Form 3160-5
(June 2019)

SUNDRY NOTICES AND REPORTS ON WELLS
Do not use this form for proposals to drill or to re-enter an abandoned well. Use Form 3160-3 (APD) for such proposals.

8. Well Name and No. HARRIER 35 NORTH FED COM/705H

EOG respectfully requests an amendment to our approved APD for this well to reflect the following changes:

Revised Wellbore

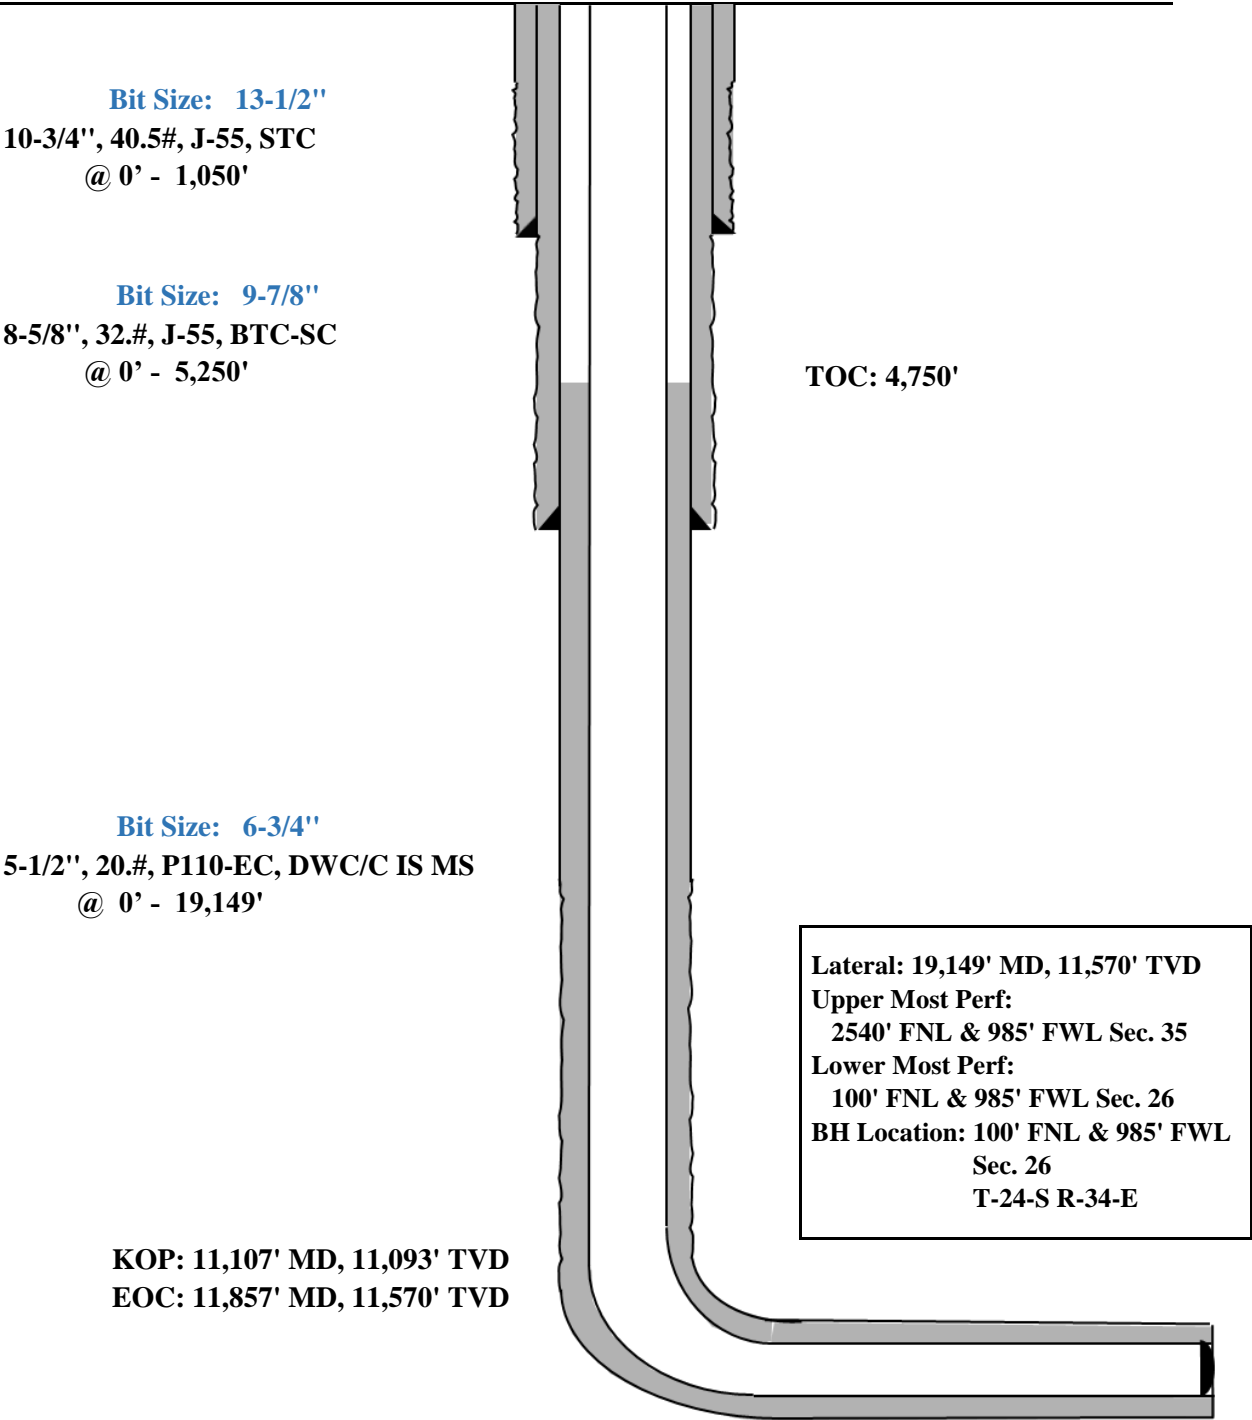
Change name from Harrier 35 North Fed Com 705H to Harrier 35 North Fed Com 591H.

Change BHL from T-24-S, R-34-E, Sec 26, 100' FNL, 1650' FWL, LEA Co., NM, to T-24-S, R-34-E, Sec 26, 100' FNL, 985' FWL, LEA Co., N.M.

Change target formation to Third Bone Spring Carb.
